Technical Service Bulletin: TSB200140

Released Date: 18-Dec-2025

Low Pressure Gear Pump and Lines

Figure 1, Existing Inlet Line Part Number 3688089 (Brown), Existing Gear Pump Part Number 4307482 (Gray), Priming Pump Part Number 3692468 (Green).

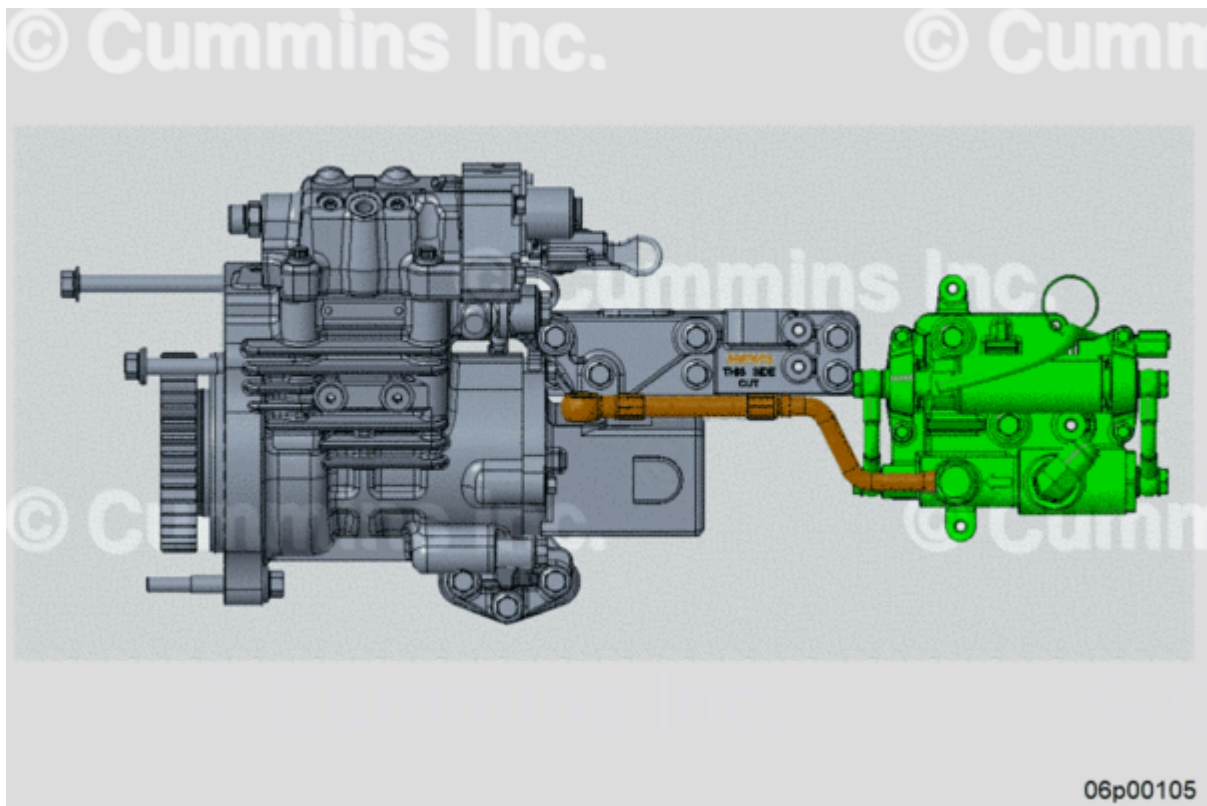
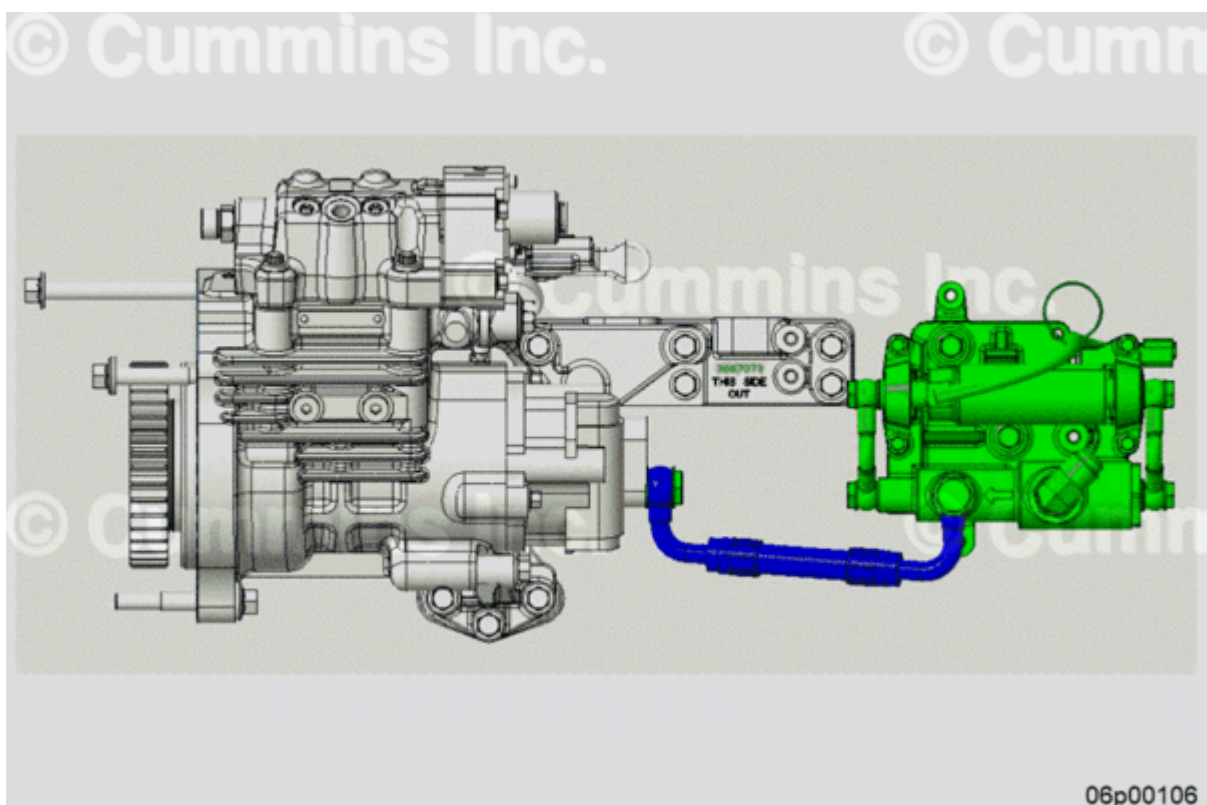
Figure 2, New Inlet Line Part Number 5575369 (Blue), New Gear Pump Part Number 5491782 (White), Priming Pump Part Number 3692468 (Green).

Figure 3, Existing Inlet Line Part Number 5440771 (Brown), Existing Gear Pump Part Number 4307482 (Gray), Priming Pump Part Number 3692468 (Green).

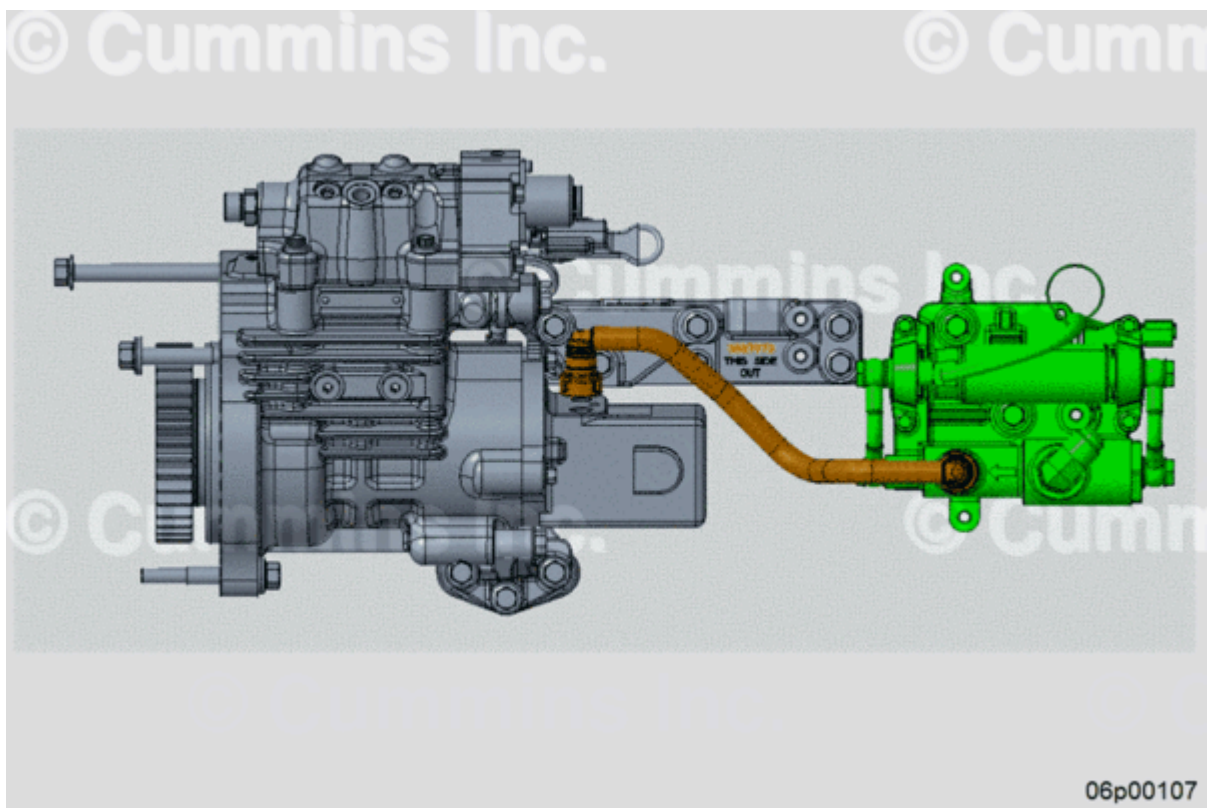
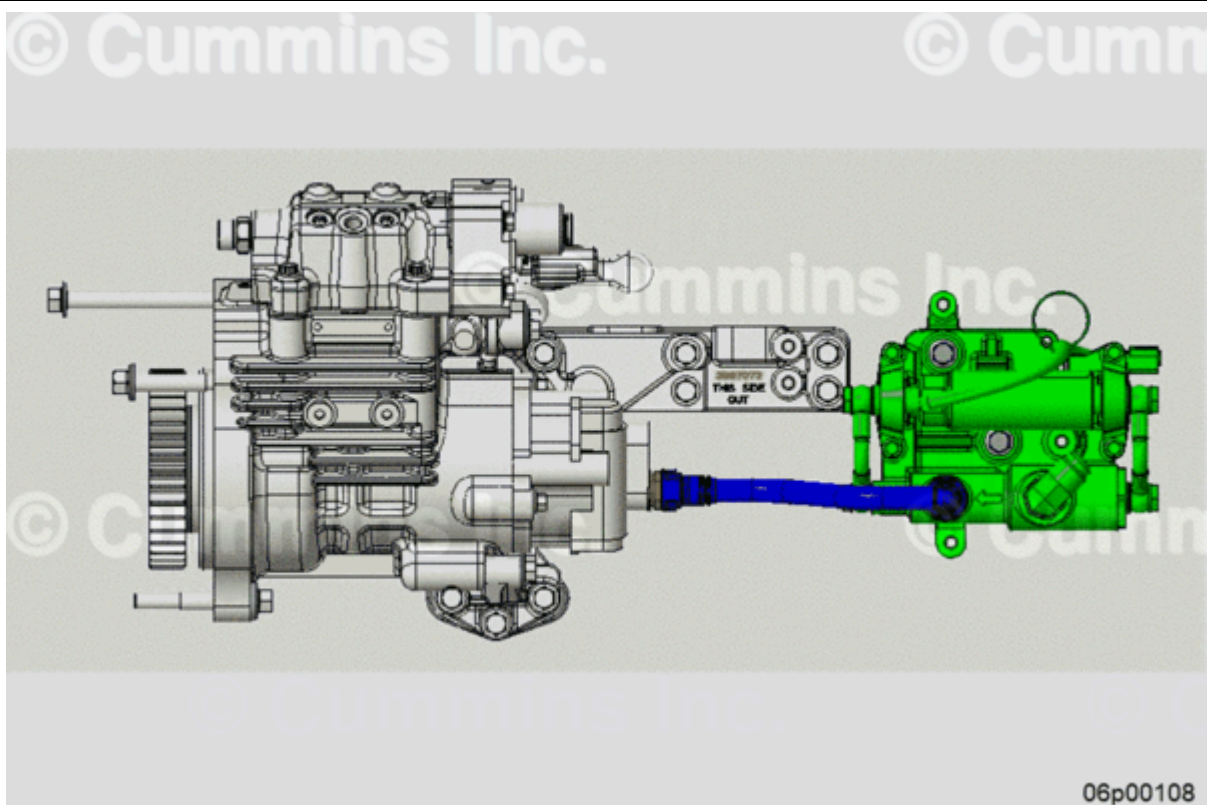
Figure 4, New Inlet Line Part Number 5481205 (Blue), New Gear Pump Part Number 5491782 (White), Priming Pump Part Number 3692468 (Green).

Figure 5, Existing Inlet Line Part Number 3689169 (Brown), Existing Gear Pump Part Number 4307482 (Gray), Priming Pump Part Number 3688896 (Green).

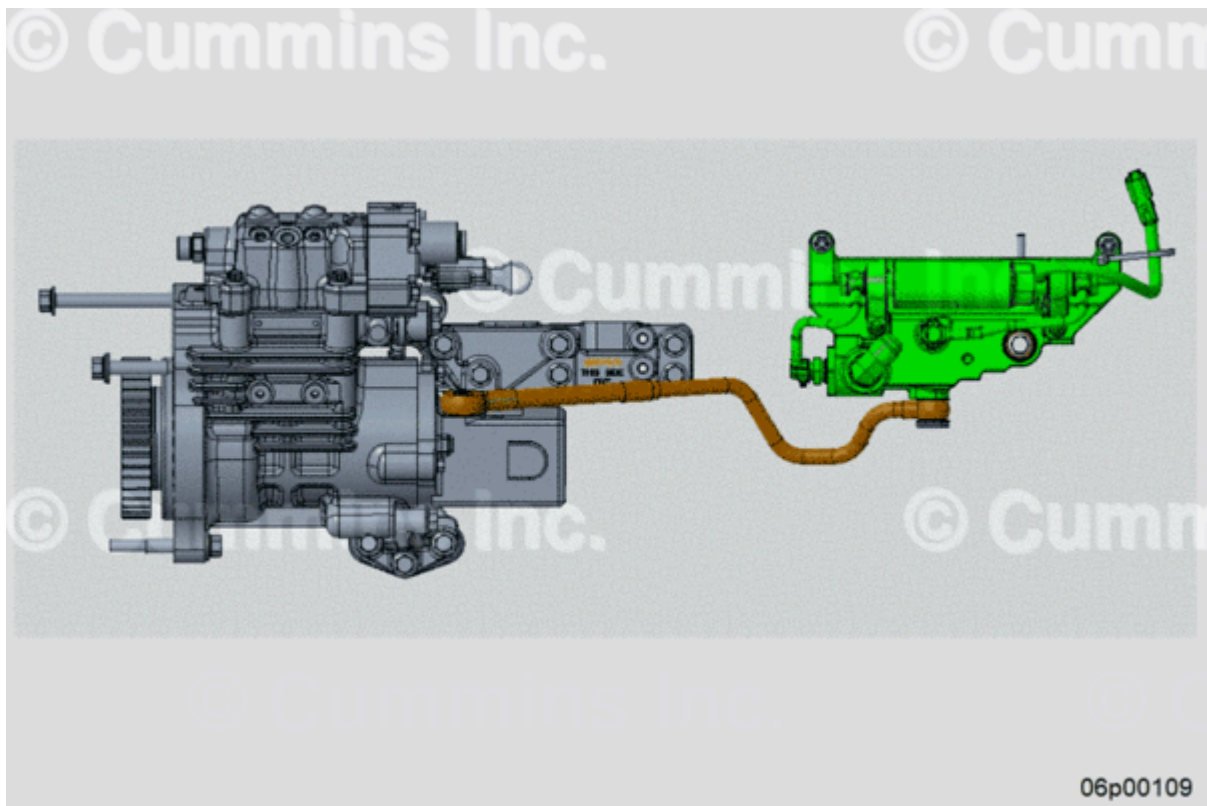
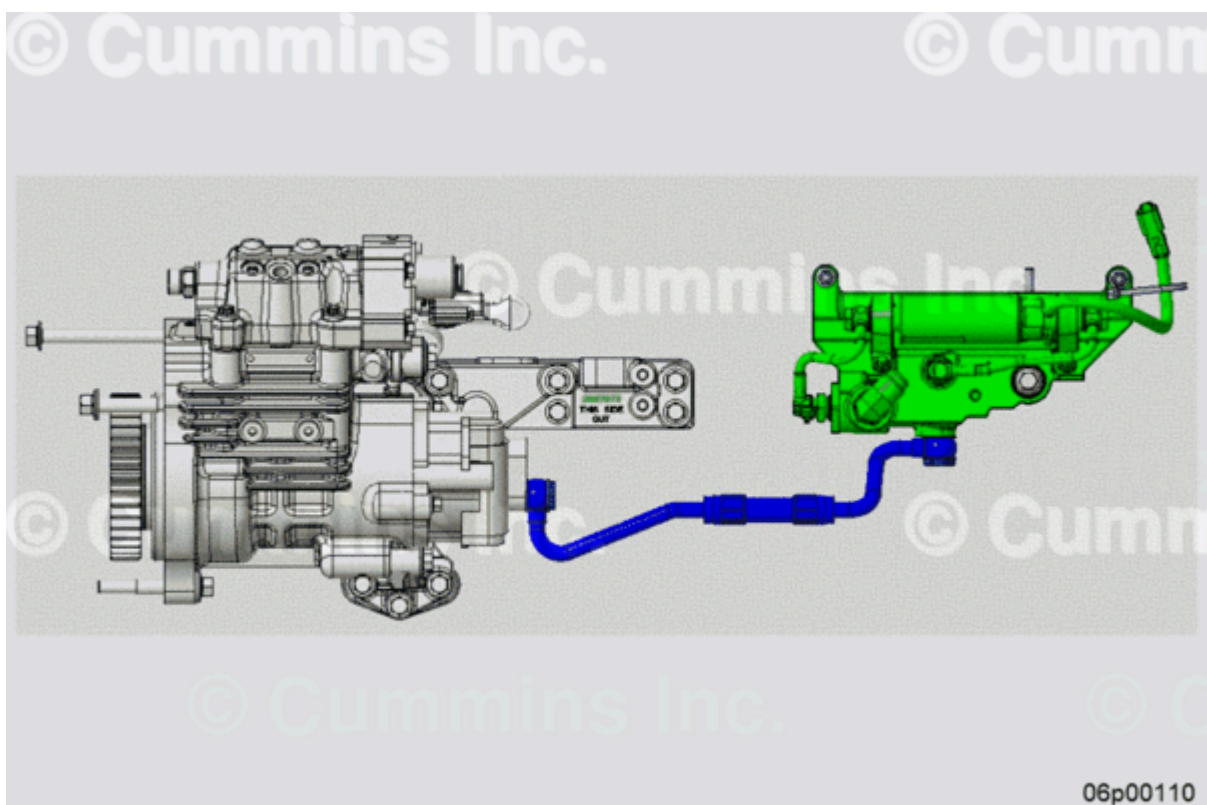
Figure 6, New Inlet Line Part Number 5575370 (Blue), New Gear Pump Part Number 5491782 (White), Priming Pump Part Number 3688896 (Green).

Figure 7, Existing Inlet Line Part Number 5440478 (Brown), Existing Gear Pump Part Number 4307482 (Gray), Priming Pump Part Number 3688896 (Green).

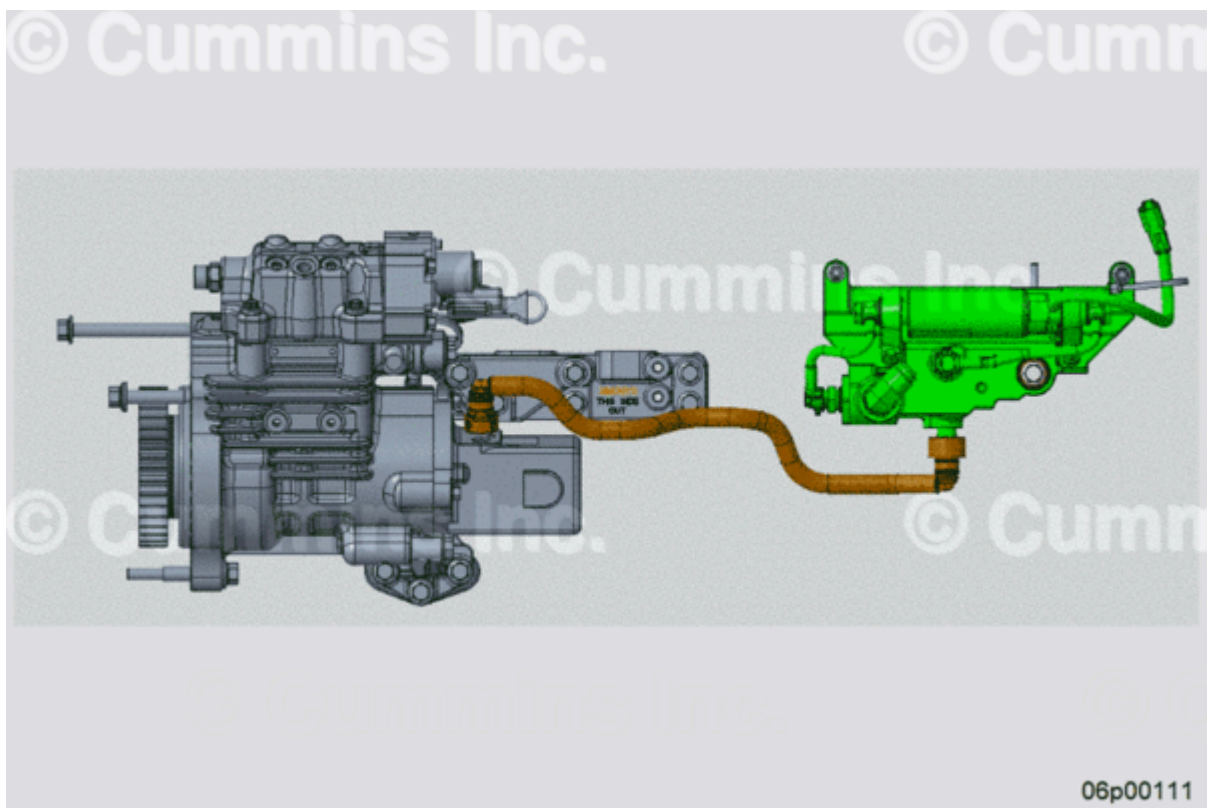
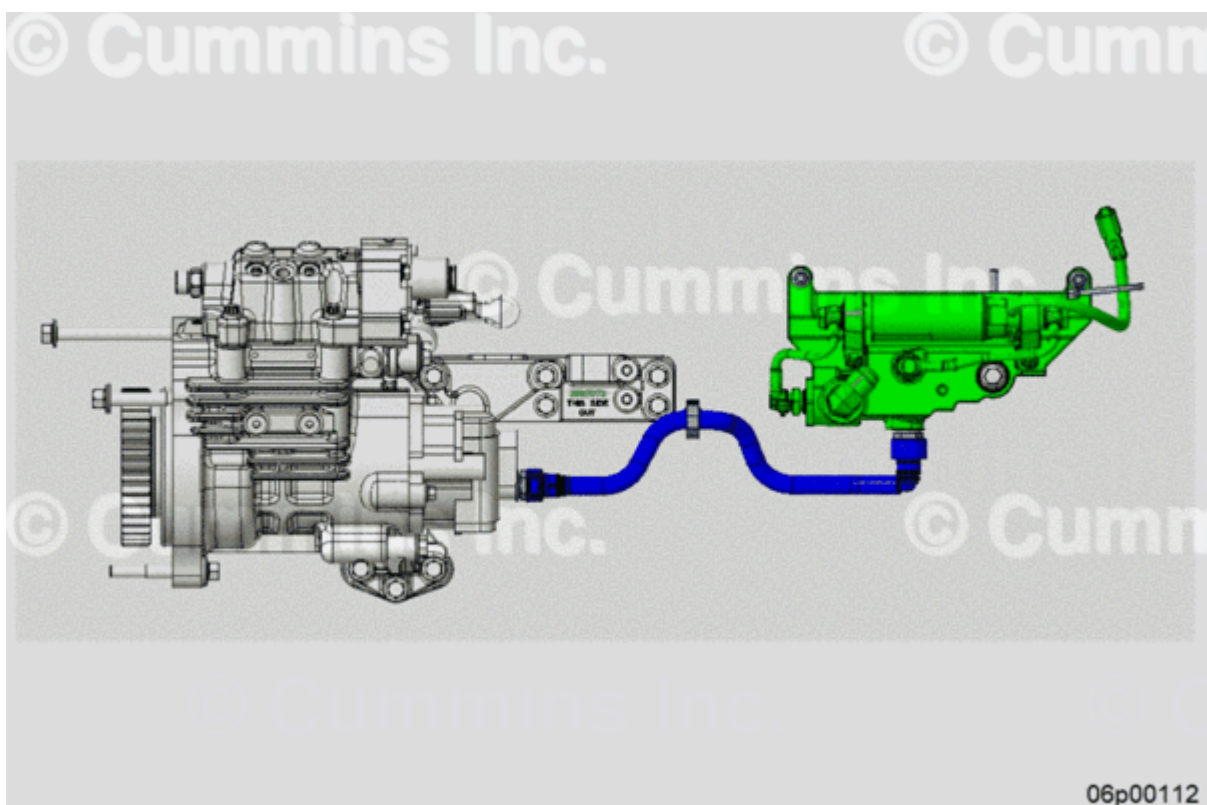
Figure 8, New Inlet Line Part Number 5481207 (Blue), New Gear Pump Part Number 5491782 (White), Priming Pump Part Number 3688896 (Green).

Figure 9, Existing Outlet Line Part Number 3688317 (Brown), Existing Gear Pump Part Number 4307482 (Gray), Fuel Filter Arrangement Part Number 3685850 (Green).

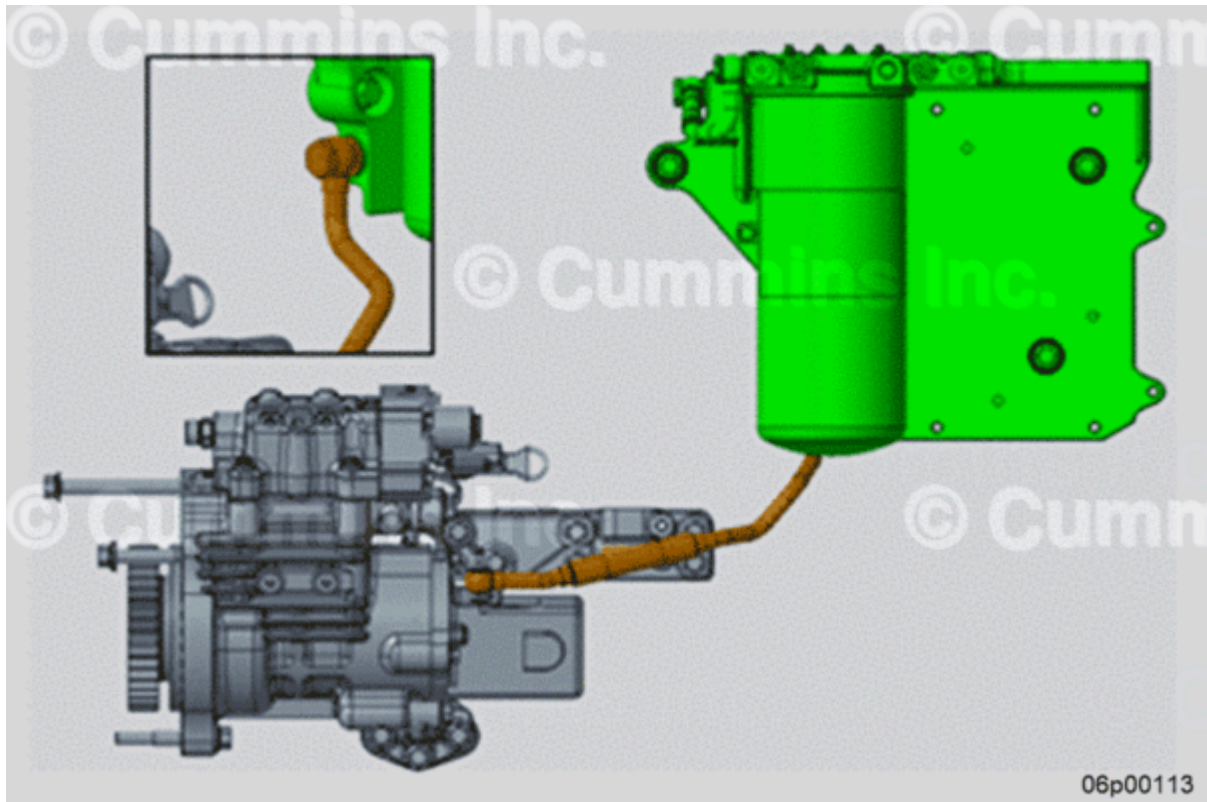
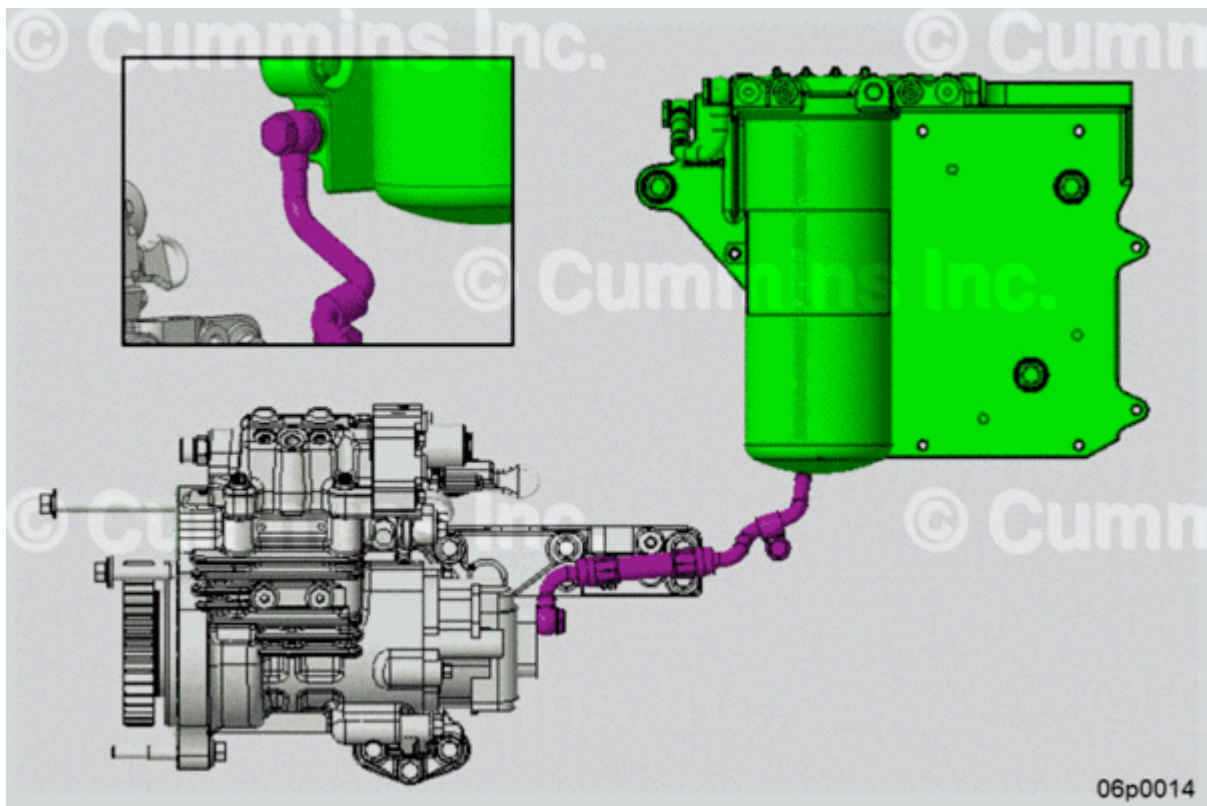
Figure 10, New Outlet Line Part Number 5575372 (Purple), New Gear Pump Part Number 5491782 (White), Fuel Filter Arrangement Part Number 3685850 (Green).
